Interactive comment on “Preflight Calibration of the Chinese Environmental Trace Gases Monitoring Instrument(EMI)” by MinJie Zhao et al.

We would like to thank you for the insightful comments. Our responses to the comments are given below.

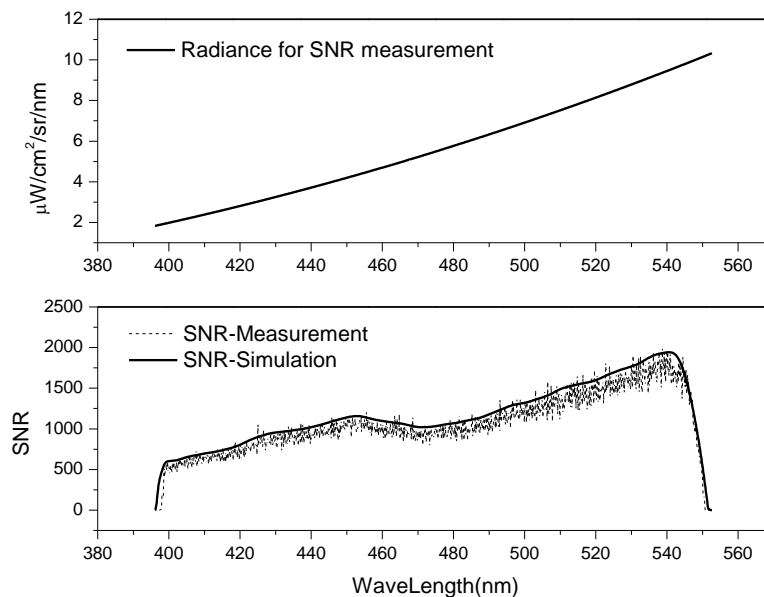
(8) The authors state that the measured SNR in figure 13 is departing from the simulation between 460-500nm due to lower transmittance of the instrument (filter) in this range. However, if the equation in line 394 includes the proper transmission function, this effect should be included in the simulation. Please explain.

Response:

The equation in line 394 includes the proper transmission function. But for the SNR-simulation, the transmittance of the filter is not included as we want to analyze the effect of the filter on SNR. The simulation SNR included the effect of the filter is shown in following figure.

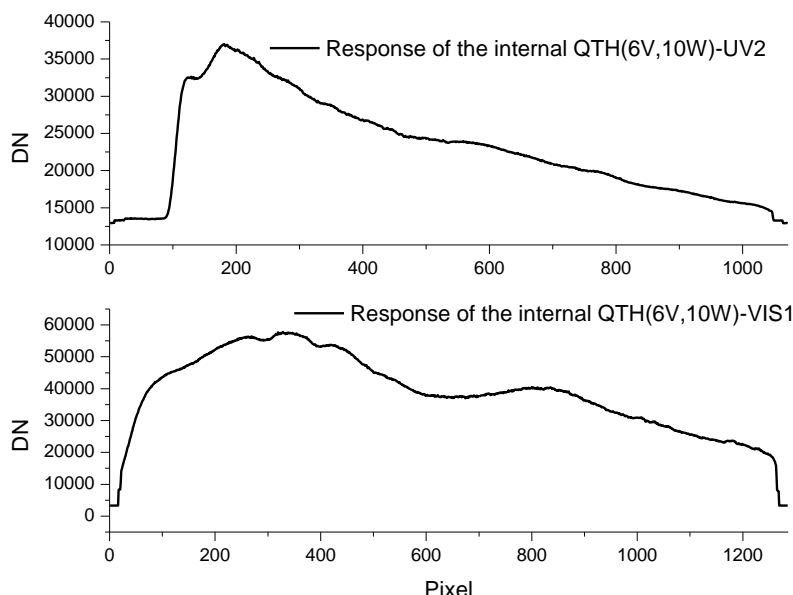
(10) If I understand correctly, the pre-flight, radiometric calibration of EMI was not conducted under flight-like vacuum and possibly thermal conditions. If this is the case, please address in more detail how the in-flight calibration will be used to accomplish absolute radiometric calibration of the flight data.

Response:

The pre-flight, radiometric calibration of EMI was not conducted under flight-like vacuum and possibly under thermal conditions due to the limitation of the calibration facility. The EMI on-ground response to the quartz tungsten halogen WLS (6 V, 10 W) is displayed in following figure, which uses UV2 and VIS1 as examples.

The EMI in-orbit response to the quartz tungsten halogen will be obtained after the launch. The change between the on-ground and in-orbit responses is used to correct the preflight radiometric calibration, which in turn is used to accomplish the in-flight absolute radiometric calibration of the flight data.
